**Proposed Residential Development (Flat) with Shop and Services Use
and Minor Relaxation of Plot Ratio and Building Height Restrictions
at Lots 531 RP, 532 S.D. RP and 532 RP in DD 130 and
the adjoining Government Land, Lam Tei, Tuen Mun
(Planning Application No. A/TM-LTTY/502)**

- Further Information No. 6 -

Response-to-Comment Table

Figure: 2.1

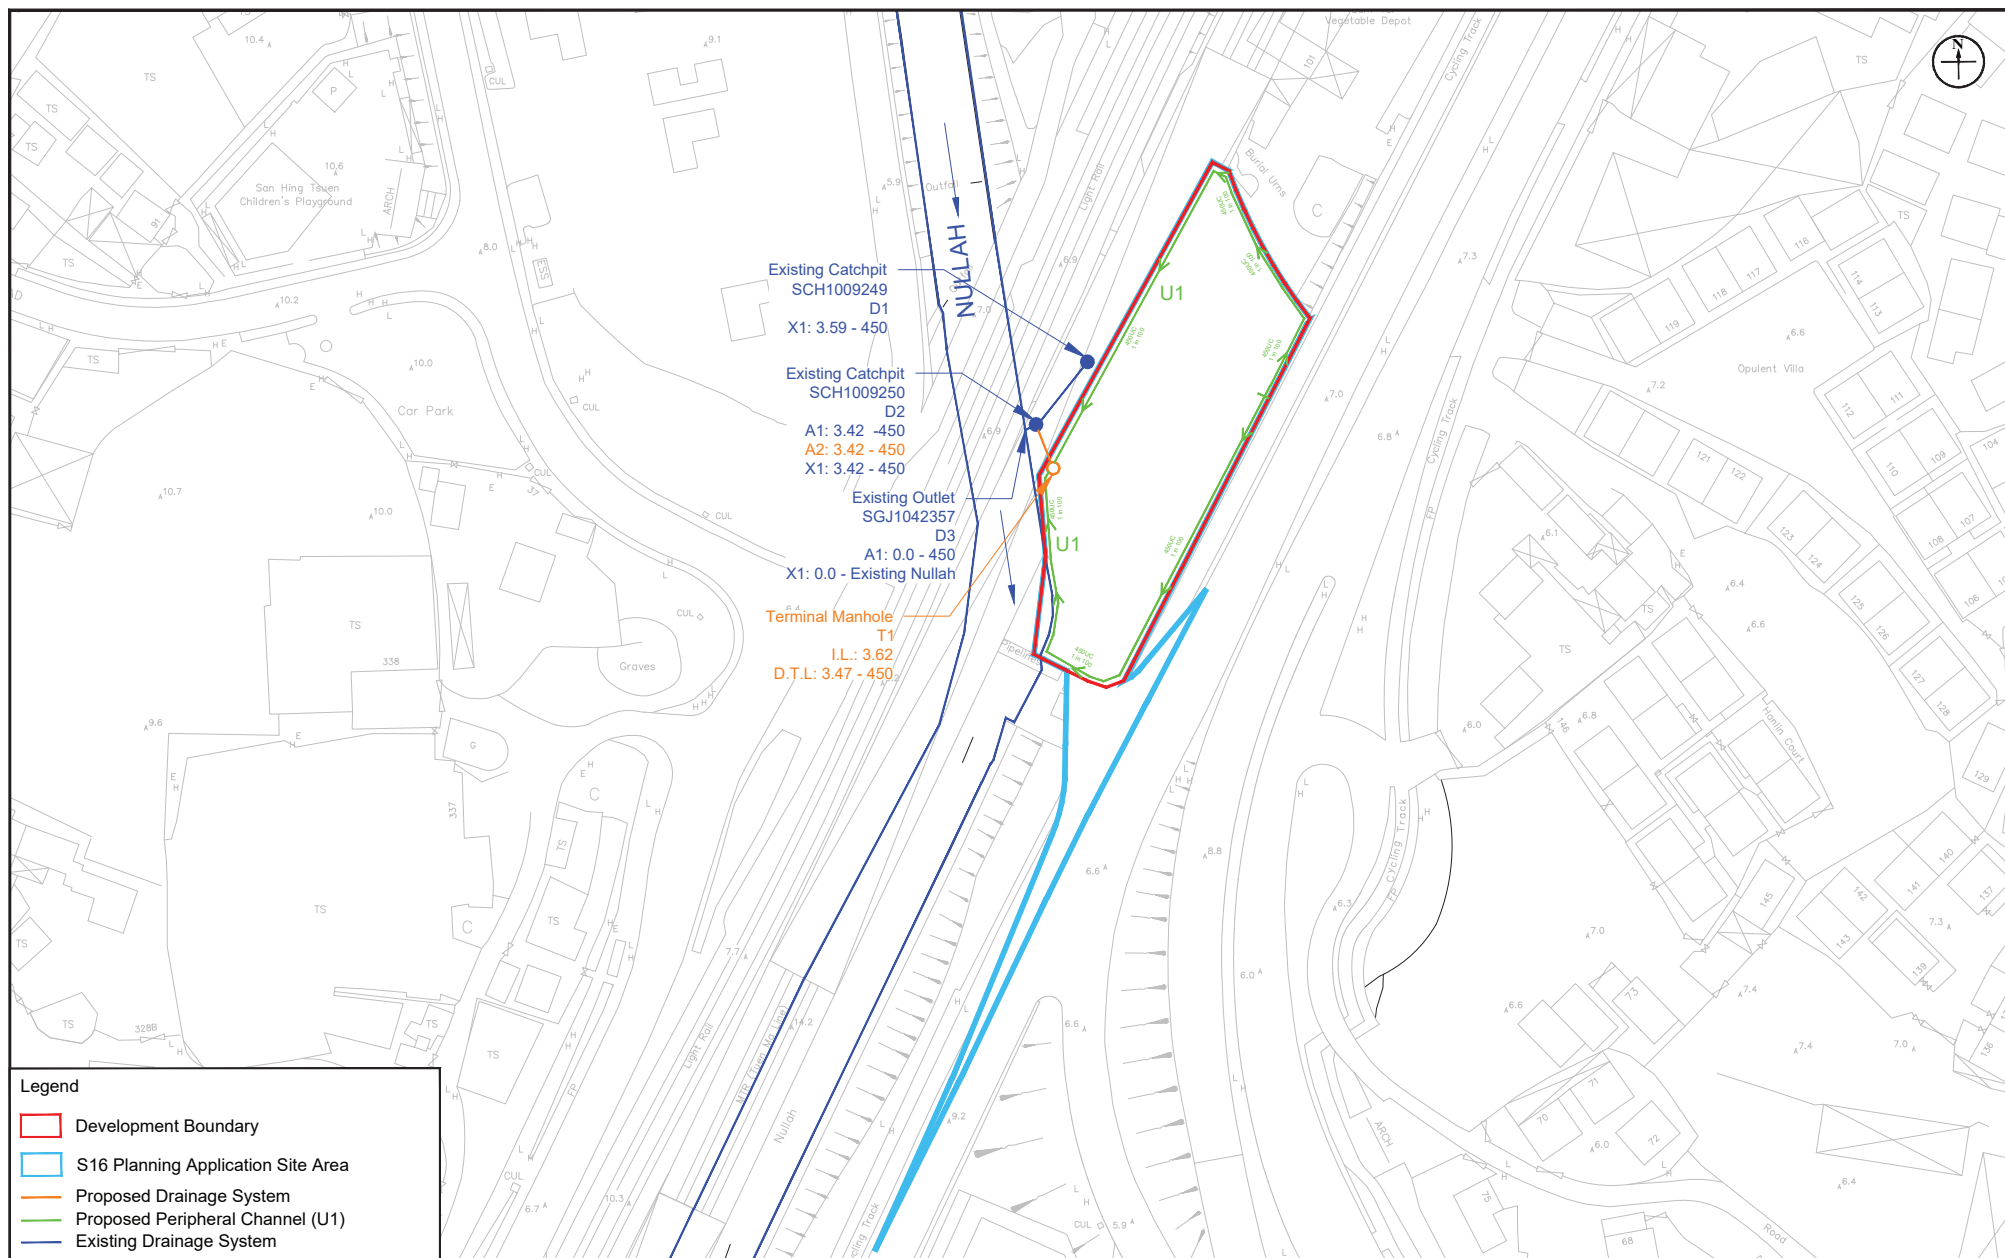
Comments	Response
<u>Comments from the Drainage Services Department</u> (Contact Person: Miss Jenny CHOW, Tel: 3965 8875) <u>Comments on DIA</u> 1. Re: Table 2.1 at Section 2.4.3, the sum of runoff from S1, STP, A1, A2 (0.115+0.015+0.056+0.006) does not equal to the total runoff 0.177 m³/s. Please review and revise accordingly. 2. Re: Section 2.4.4, 2.5.4 and 3.1.3, further to Comment 1 above, please revise the total discharge volume of Site (i.e. 0.13 m³/s) accordingly. 3. Re: Appendix 2.1 Detailed DIA Calculation, a. For Table 2b, the estimated effluent 0.018 m³/s does not tally with the content throughout the report (i.e. 0.015 m³/s in Section 2.4.4 and Section 2.5.3). Please review and revise. b. For Table 3a, the downstream manhole reference for both segments are missing. Please supplement. c. For Table 4a, the downstream manhole reference for both segments are missing. Please supplement. <u>No Comment on SIA</u>	Noted, Table 2.1 has been revised accordingly. The estimated effluent of STP is 0.015m³/s, thus the total discharge volume of the development boundary is 0.13m³/s. Therefore, no update is required for Sections 2.4.4, 2.5.4 and 3.1.3. The estimated effluent of STP is 0.015m³/s. Appendix 2.1 has been updated accordingly (Appendix I refers). Noted, relevant information has been added. Noted , relevant information has been added. Noted.
